[Docket No. FAA–2008–0490; Directorate Identifier 2008–SW–26–AD; Amendment 39–15509; AD 2008–10–03]

#### Airworthiness Directives; Bell Helicopter Textron Model 204B, 205A, 205A–1, 205B, 210, 212, 412, 412CF, and 412EP Helicopters

**ACTION:** Final rule; request for comments.

T/R Blade Assembly  
Figure 1

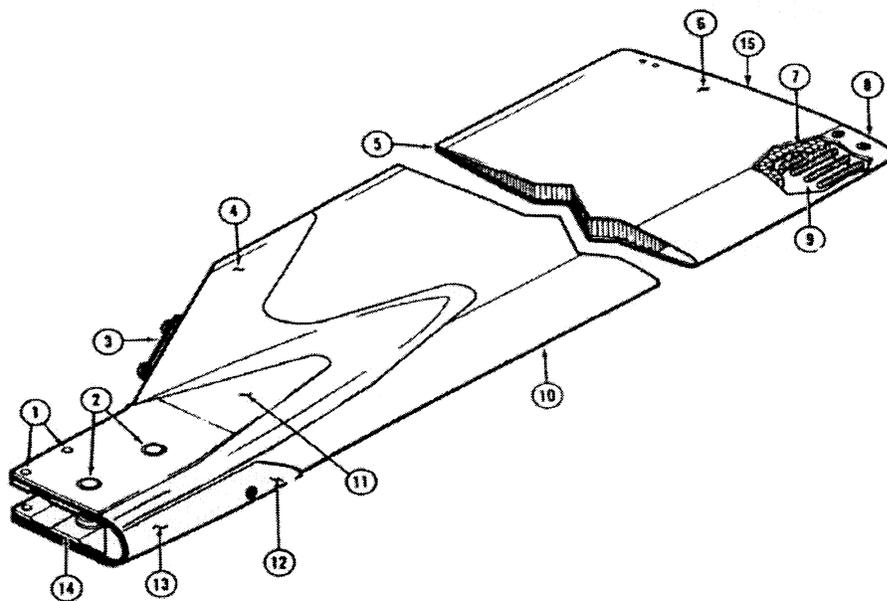
<p>Recommend changing areas called out for special attention to Stations 25.0 to 35.0 (both sides) for damage/corrosion and include inboard blade butt area surrounding balance weights/screws for cracks.</p>	<p>While the standard Model 204B helicopter may not use this particular T/R blade, the 212-010-750 T/R blade may be on a modified Model 204B helicopter that does use this blade. To assure that we have covered all affected blades, the applicability now encompasses all affected dash-numbered T/R blades.</p>
<p>There have not been eight reported failures, there have been three. All others are reported cracks in the blade skin, not “failures.” The term “failure” can be misleading.</p>	<p>Agree with this change and have revised this AD accordingly.</p>
<p>Bell objects to our statement in the NPRM that “The requirements of the proposed AD would be interim actions until either a more rigorous inspection is developed or a new blade that is more damage tolerant is designed.” Bell states “Although we are in concept discussions with DND, completion and certification of this blade is many months away and could be misleading to the commercial community.”</p>	<p>A crack in a blade makes that blade unable to safely perform its intended function. Thus, there are now 9 T/R blades that meet that criteria.</p>

(2) Using a 3-power or higher magnifying glass and a bright light, visually inspect the T/R blade skins, leading edge spar, doublers, grip plates, and trailing edge for a crack, corrosion (may be indicated by blistering, peeling, flaking, bubbling, or cracked paint) and any other damage (including a nick, scratch, or dent). See Figure 1 of this AD. Pay particular attention to both sides of the T/R blade in the area located 16 to 26 inches from the T/R blade tip (blade station 25 to 35—the T/R blade tip is located at blade station 51) and to the inboard blade butt area near the attachment of the external balance weights

and screws. Also pay particular attention to any blade surface that was snagged by the
